The future of Moore Park South - Bicycle NSW feedback

Thank you for the opportunity to provide feedback on the plans for the future of Moore Park South.

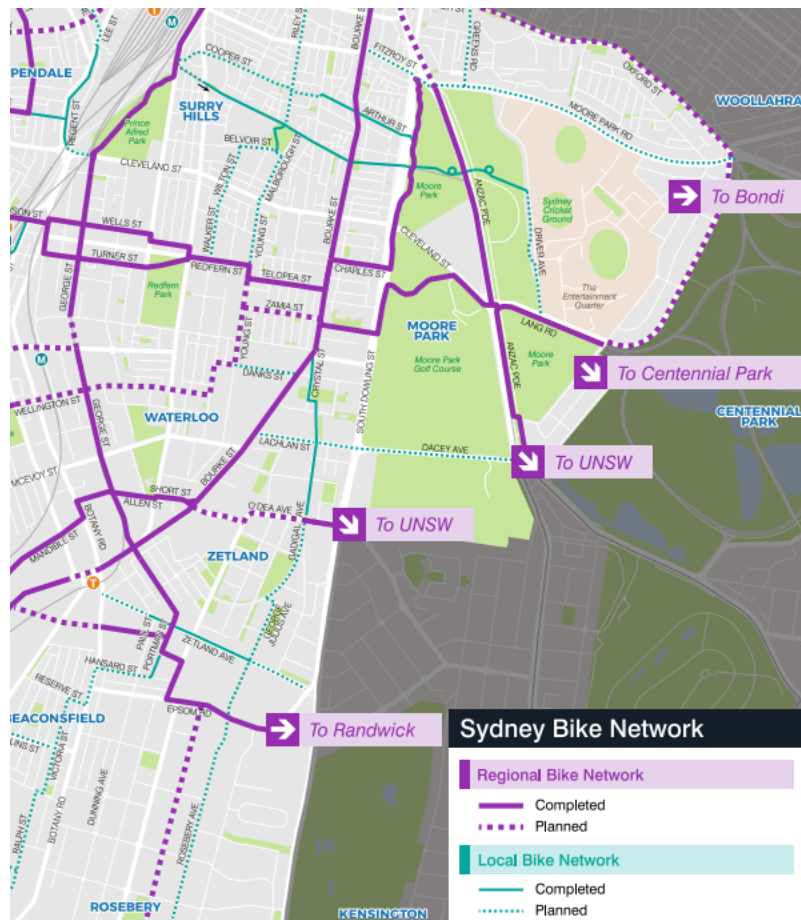
- It is essential to focus on access by foot, bike or public transport. We do not want to see more asphalt car parking. The land is too valuable and the need for greenery and tree canopy too pressing.
- New signalled crossings are needed to enable safe access to/from Moore Park South. Marked pedestrian / cycle crossings must be installed on every leg of every intersection, signalled or unsignalled. Forcing people to cross 3 legs instead of one will result in people taking risks to avoid waiting for such a detour.
- **We urge Greater Sydney Parklands to maximise opportunities to incorporate new cycling facilities, and upgrade existing routes, in and around the new park.** The map below highlights missing links in the local and regional bike route network.

Dacey Avenue is a key priority for a safe cycleway and wider walking paths. This could be achieved by using some space in the park, or reallocating roadscape by reducing or narrowing vehicle lanes. A footpath and cycleway (or possibly a shared path if space is constrained) on both sides of Dacey Avenue would be ideal to maximise connectivity, particularly if the signalised intersections at either end of the road continue to prioritise cars.

A path along the southern edge of the park should be incorporated into the plans, as well as improved access to the rear of the SupaCentre.

A shared path (or even better, a separated cycleway using existing road space) along the western side of Anzac Parade is also recommended. The high quality path on the eastern side is very difficult to access from Moore Park South. The only mid-block crossing requires multiple light phases for pedestrians and bikes.

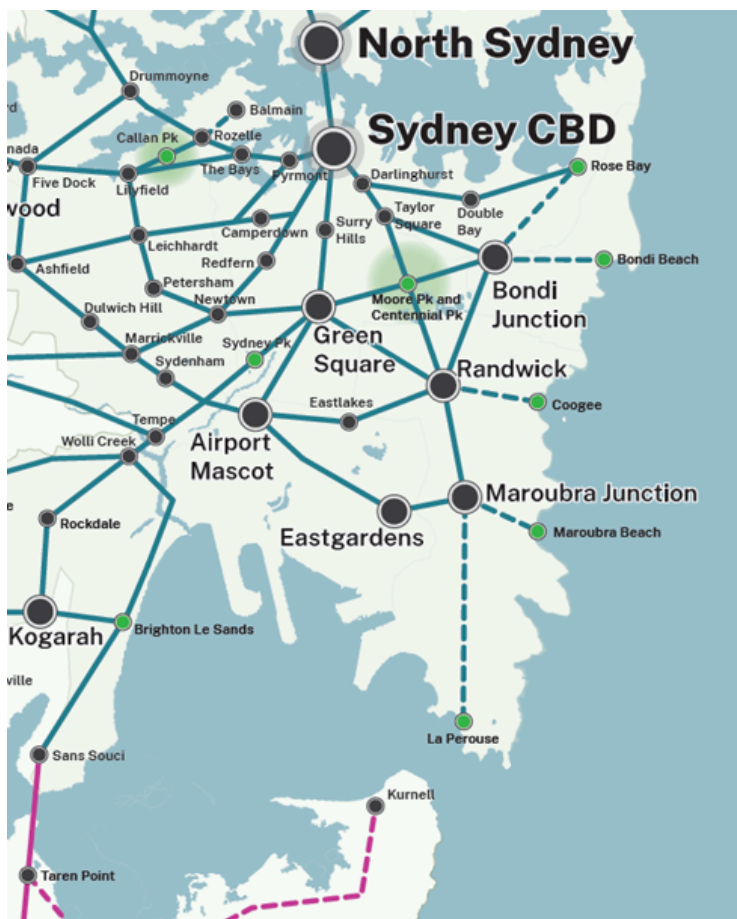
- In 2022, Transport for NSW released the [Eastern Harbour City Strategic Cycleway Corridors](#). The 30 corridors aim to connect key centres such as Randwick, Eastgardens and Maroubra Junction. Exact routes will be subject to detailed design and collaboration with councils and the community. The extract from the network map shows the area relevant to Moore Park South. **New and upgraded paths around the park must contribute to the Green Square - Bondi junction corridor and improve the Taylor Square to Randwick corridor.**
